SB-10056286-7286

Modify Harness When Replacing Rear Door

Some internal features of the rear doors changed in late February 2014. Although new doors are compatible with existing vehicles, they do not have the same mounting points for the door electrical harness.

Figure 3

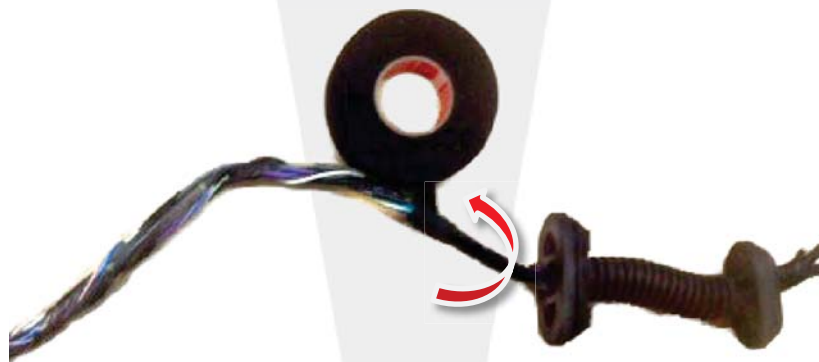
6. Wrap the wires between the grommet and the junction with abrasion-resistant wire harness tape, overlapping the tape with each rotation (Figure 3). Ensure that no wires are exposed.

Figure 6 (LH rear door shown)

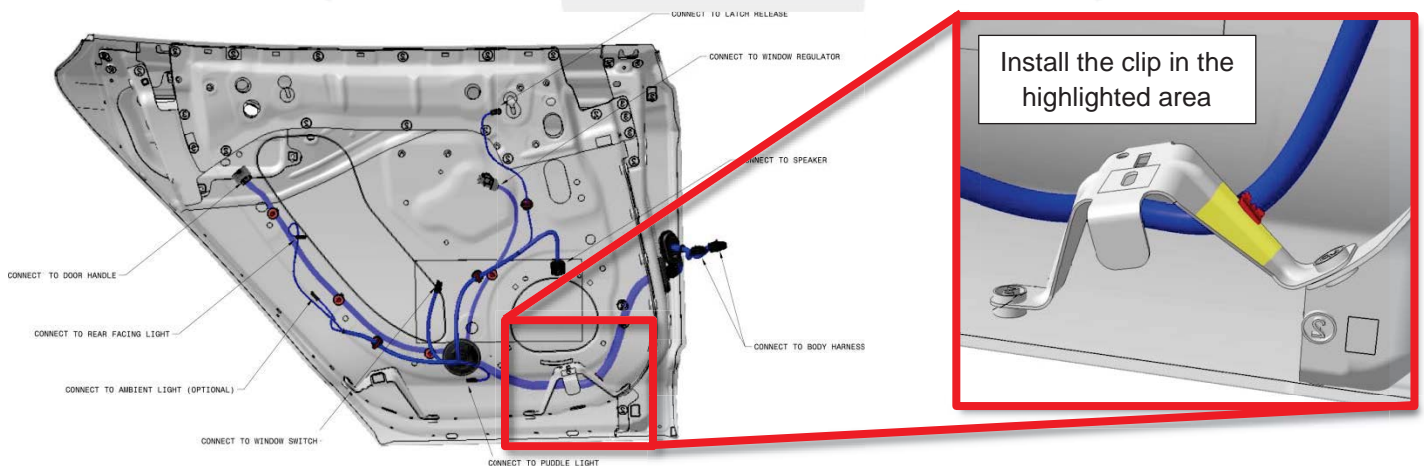
9. When installing the modified harness, attach the new edge clip to the outboard edge of the forward window regulator bracket (Figure 6).

! CAUTION: To prevent damage to the harness, ensure that the edge clip is installed in the highlighted area (Figure 6).
